SAGEMCOM BROADBAND SAS

Class II Change Letter

Request for Class II Permissive Change

FCC ID: VW3FAST5290 / Grant Date: 01/26/2022, 03/24/2022, 08/06/2021

F5290 Top different

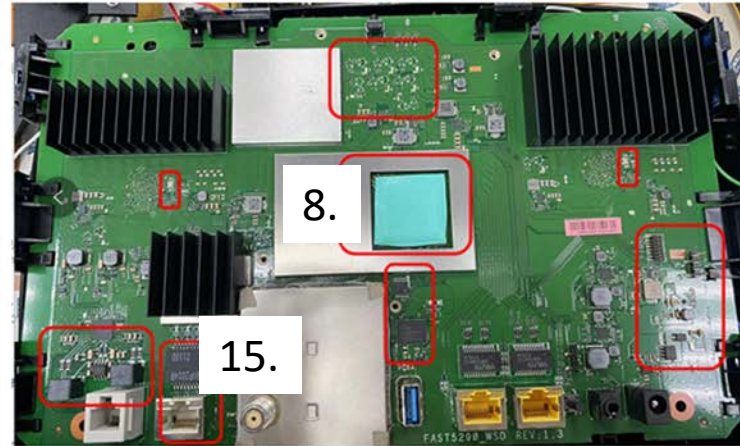
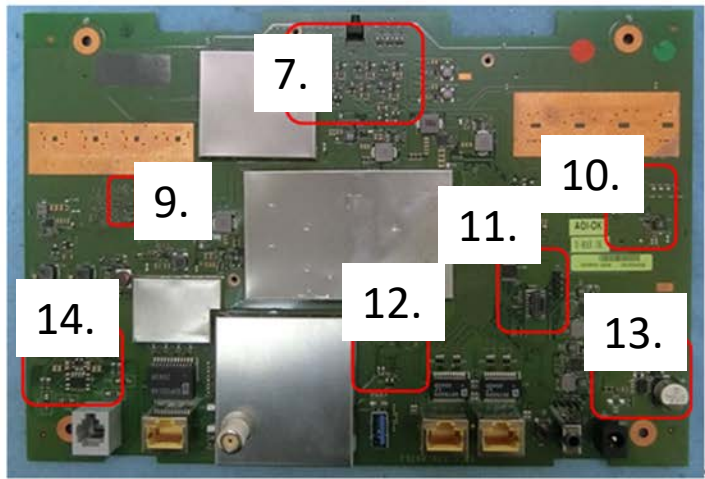
- 7. To optimize WIFI power control
- 8. Add thermal pad for CPU thermal solution
- 9. To optimize WIFI power performance
- 10. To optimize WIFI power performance
- 11. For GPIO extender move
- 12. Co-layout EMMC flash for flash shortage issue
- 13. To optimize Power DC/DC
- 14. To optimize FXS surge protection
- 15. 2.5G white Ethernet connector change to yellow

F5290 Bottom different

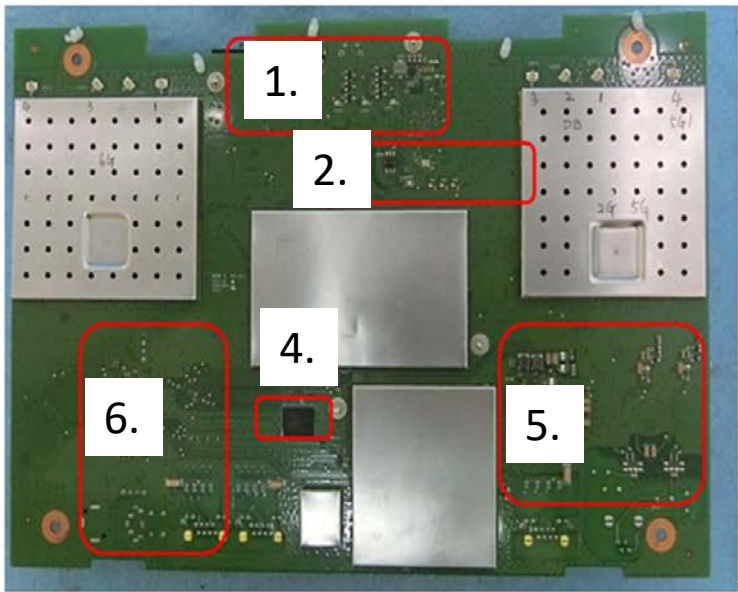
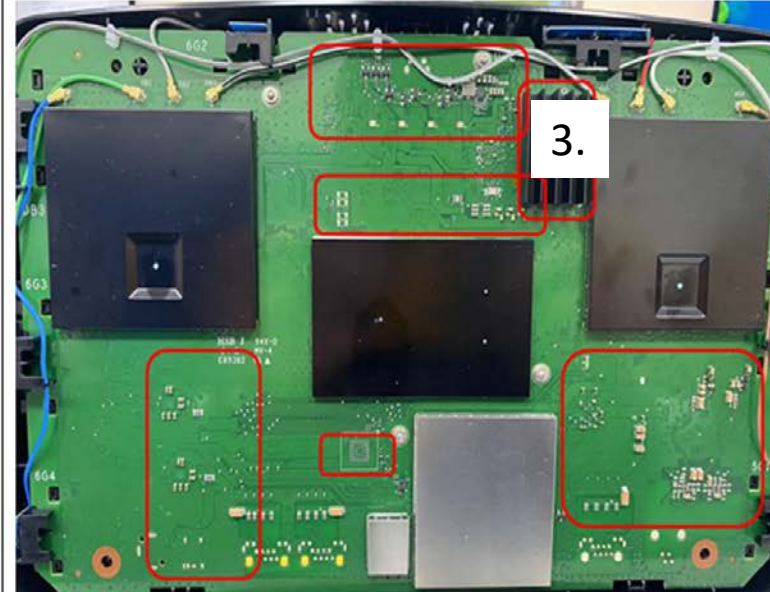
1. To optimize WIFI power control
2. DC/DC move to add 2.4G Heat sink for thermal solution
3. Heat sink for 2.4G thermal solution
4. Co-layout EMMC flash for flash shortage issue
5. To optimize MoCA DC/DC performance
6. To optimize ethernet 2.5G performance
